## FINAL OCCUPATION CERTIFICATE

Alterations and Additions at  
193 Whale Beach Road,  
Whale Beach, NSW, 2107

**Project: Alterations & Additions**  
**193 Whale Beach Road**  
**PALM BEACH, NSW**

Inspection Type: 9. Steel & Timber Framing Inspection 1

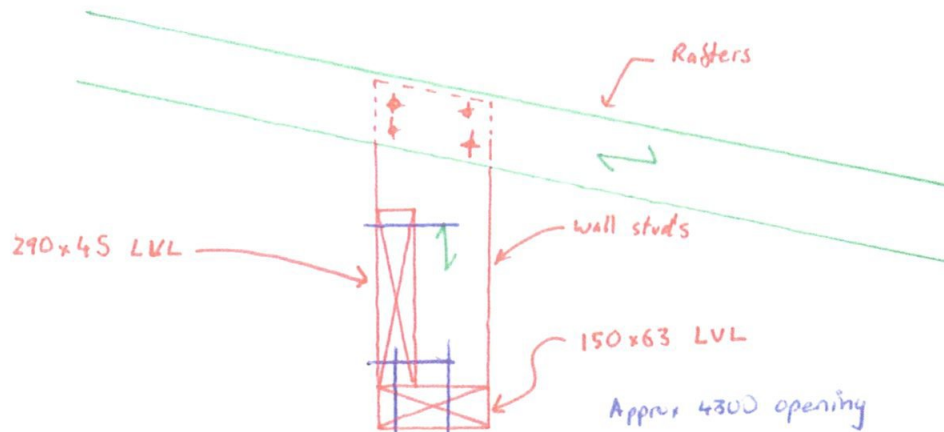
1. The steel and timber framing for the first floor and the upper levels walls had been installed and generally appeared to be in accordance with the engineering drawings & the design intent. The builder was instructed to undertake the following:

- a. Provide packing etc as lateral restraint to SB28.
  - b. Provide an additional 2 / full height studs on each side of the upper roofs L31, from top to bottom plate.

- c. Provide fixings to secure the SB33 beams from lateral movement at each end.
  - d. The builder requested a birdsmouth to the R21 & R31 rafters. A maximum 16mm birdsmouth was agreed. Do not overcut the birdsmouth.

- e. The bolted steelwork connections would interfere with the raised ceiling linings, the bolts may be removed and the beams welded to the column end plates. Typical for SB21, SB22, SB23, SB24. Reinstate the corrosion protection with Jotun 'Barrier' zinc rich 2 part epoxy

- f. The intermediate walls on each side of the entrance space require lintels which may be constructed as follows.
